**Minor  
Modification  
Request**

**RE: Review of Request for Landfarm Minor Modification  
T-n-T Environmental, Inc.  
Permit NM1-008 (Evaporation Ponds and Landfarm)  
Location: SE/4 of Section 7 and SW/4 of Section 8 (evaporation ponds) and the  
SW/4 SE/4 and SE/4 NW/4 of Section 5 and NE/4 NW/4 of 8 (landfarm), Township  
25 North, Range 3 West, NMPM, Rio Arriba County, New Mexico**

## APPLICATION FOR SURFACE WASTE MANAGEMENT FACILITY

RE: Landfarm minor modification

HAND FARM MAP

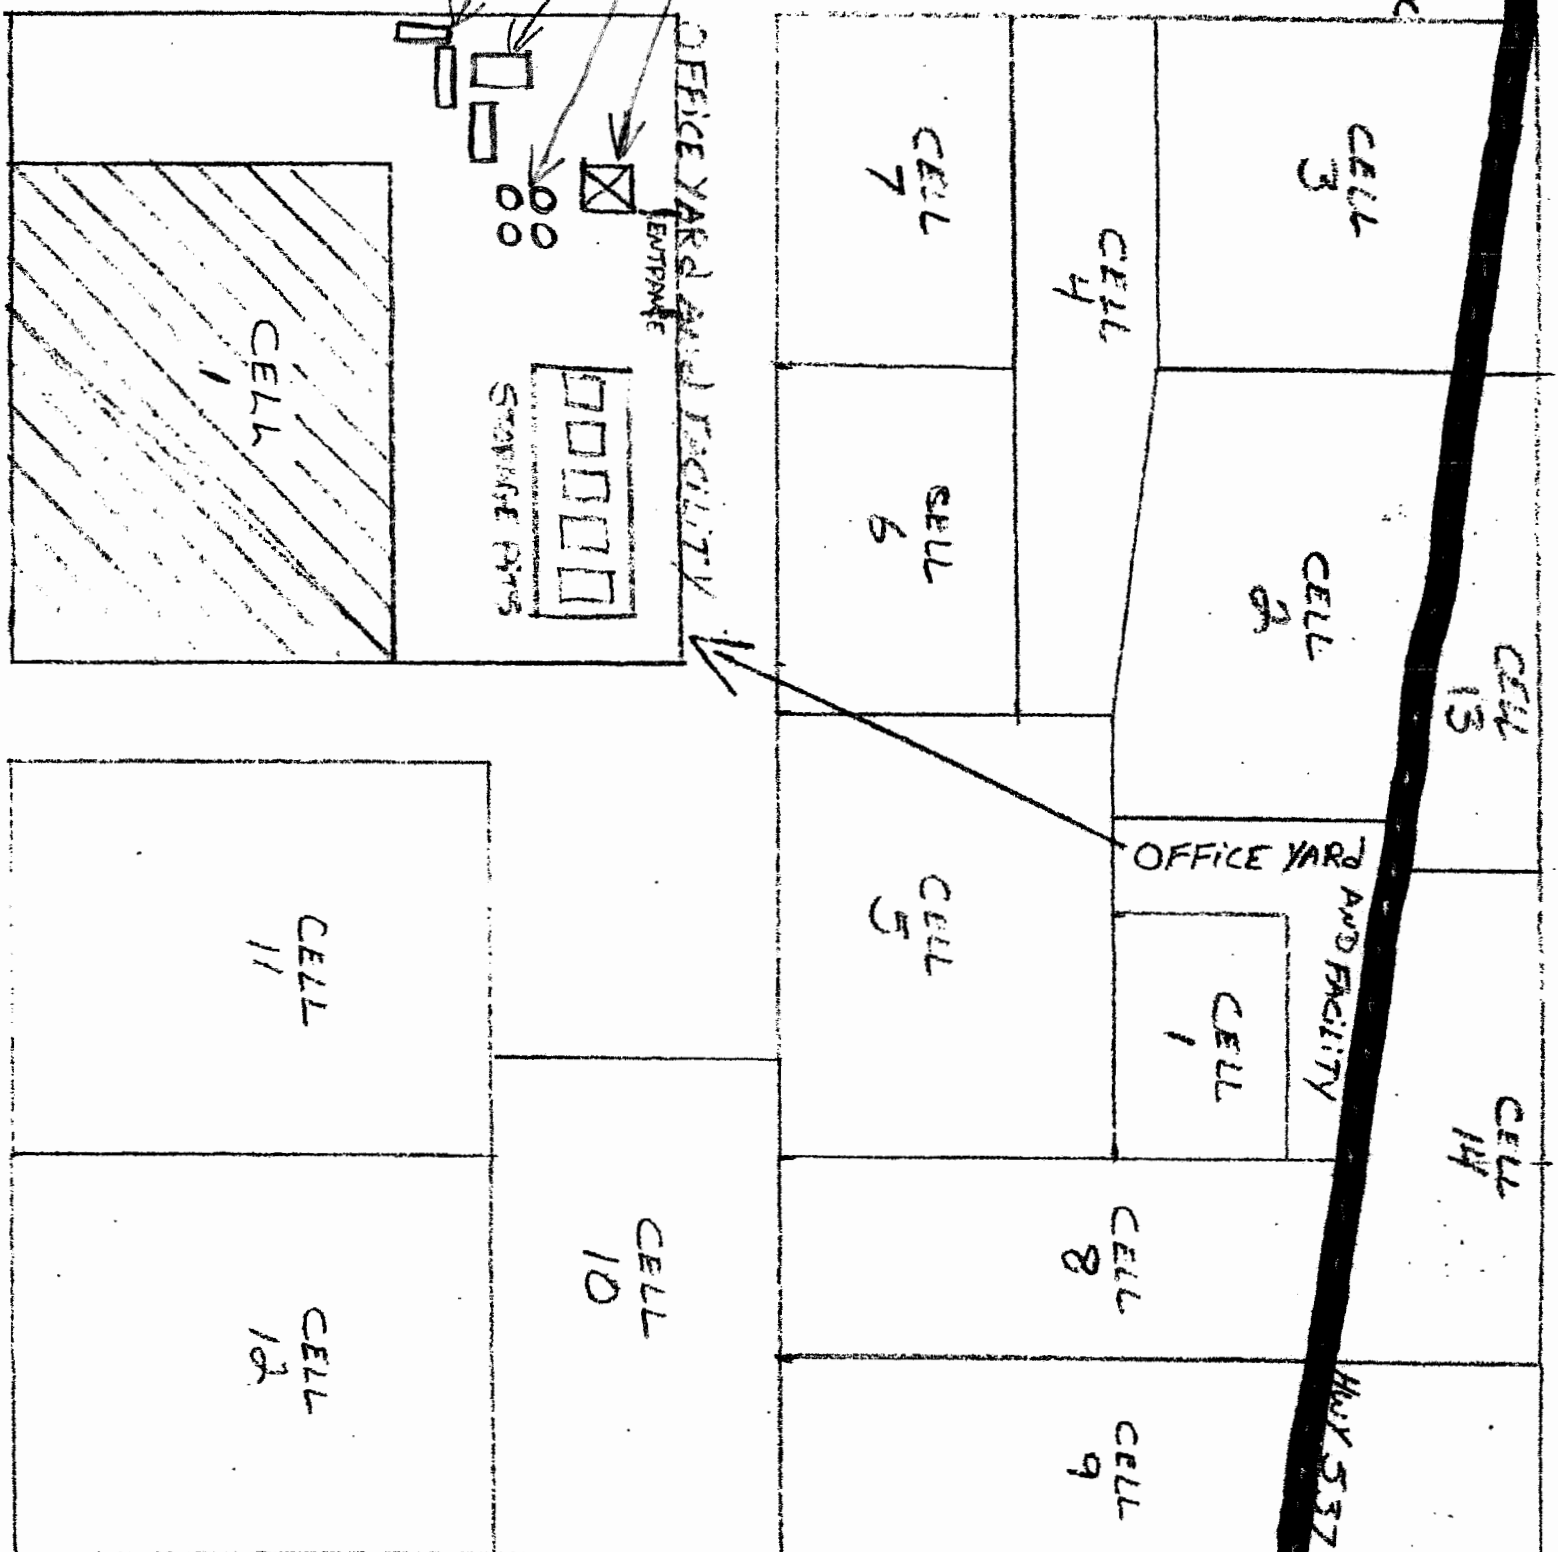
Also included is an updated facility map of the land farm.

HAND FARM MAP

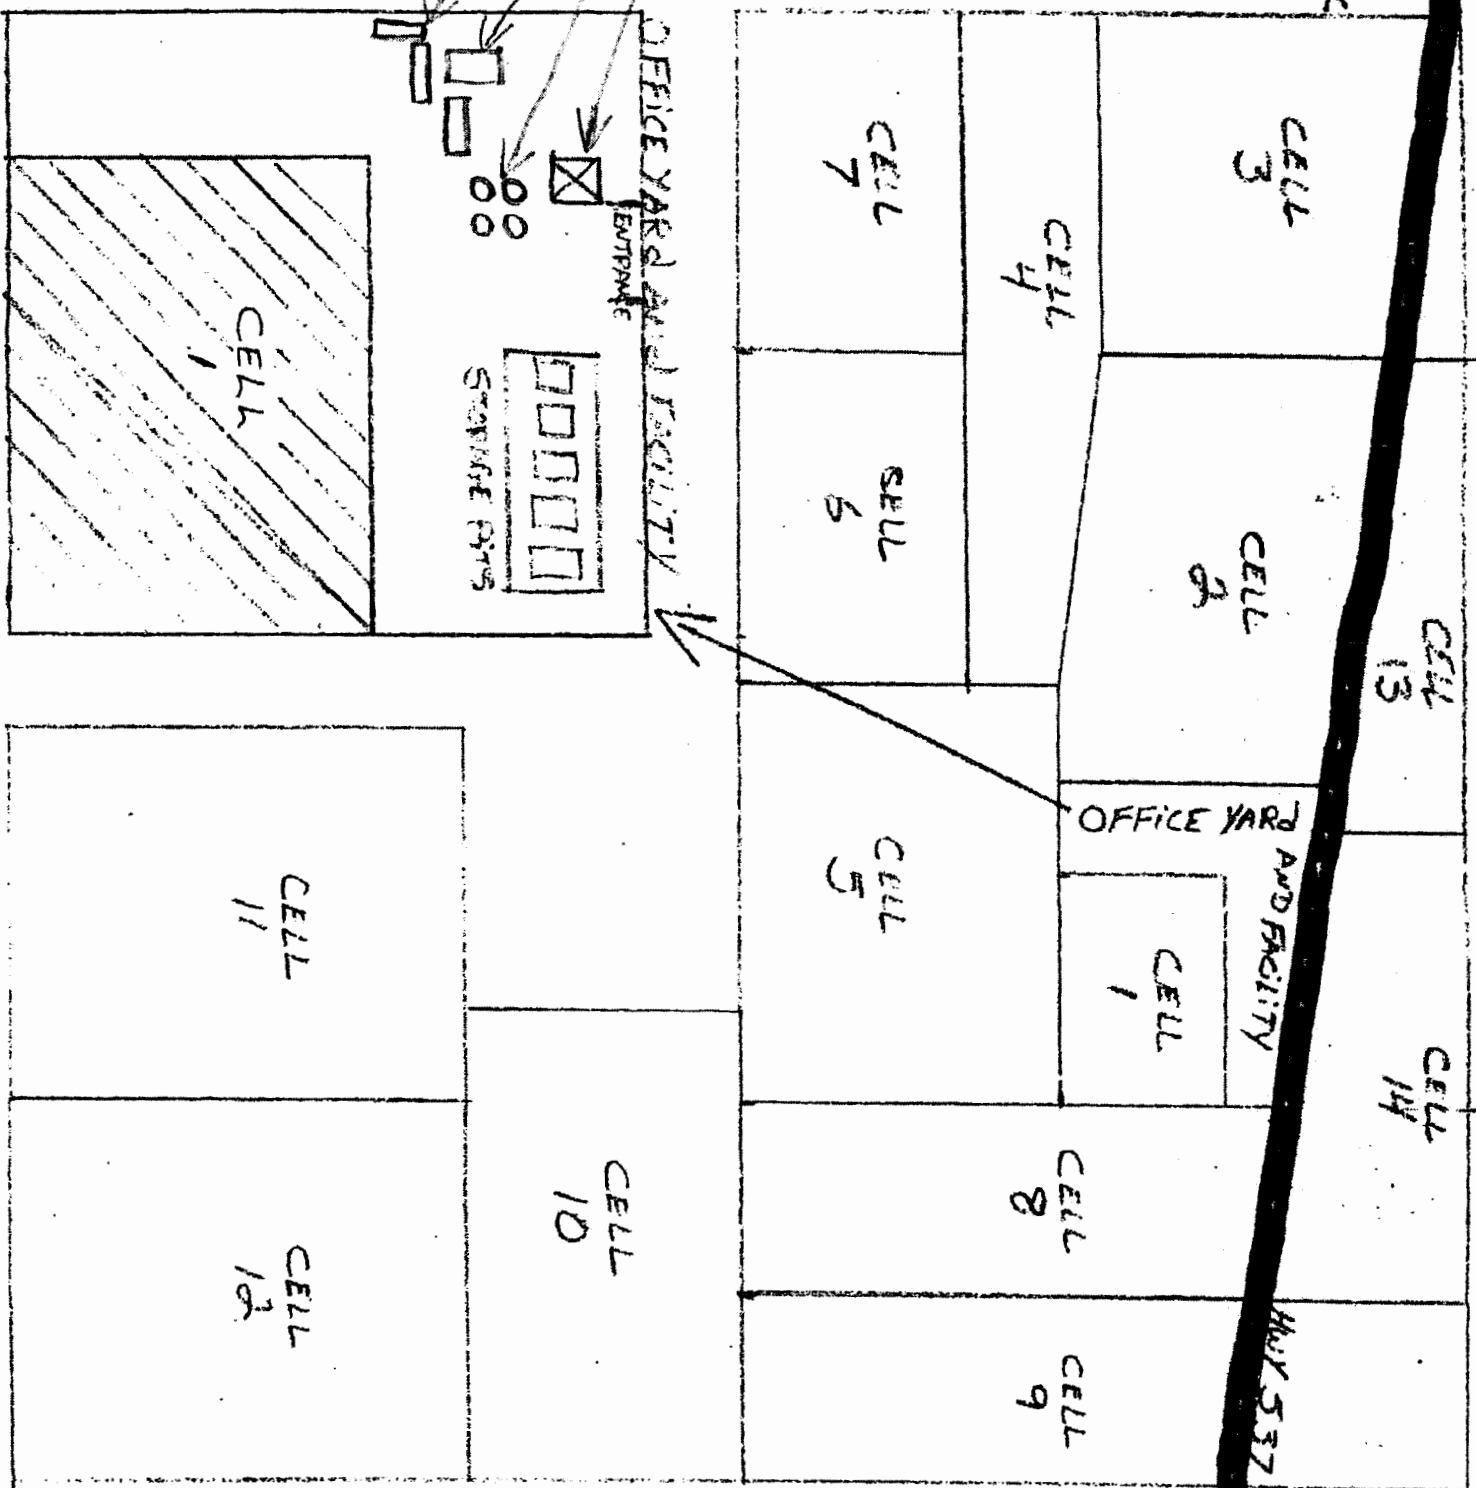
Also included is an updated facility map of the land farm.
